REVIEW

Our Ref:
HC2014/12

Date: 27 October 2014

Re: **Mount Owen Continued
Operations - Groundwater
Impact Assessment Peer
Review**

Figure 3-5 – Observed vs. Simulated Levels for all Alluvial Bores

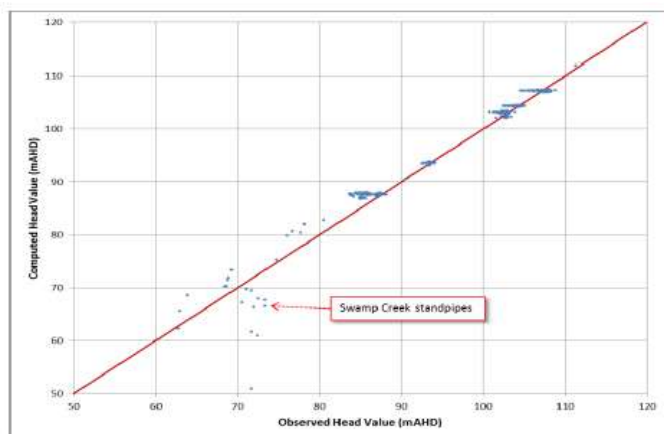
The scattergrams in Figure 3-5 (for alluvium) and Figure 3-6 (for hard rock) - reproduced below - show diagnostic features of the model's performance.

The horizontal lines in Figure 3-5 are due to the model's inability to match natural fluctuations, due either to the values adopted for specific yield or use of a stress period (1 year) that is too long. The sloping lines in Figure 3-6 suggest that the model generally is unable to reproduce the strength of drawdowns caused by mining.
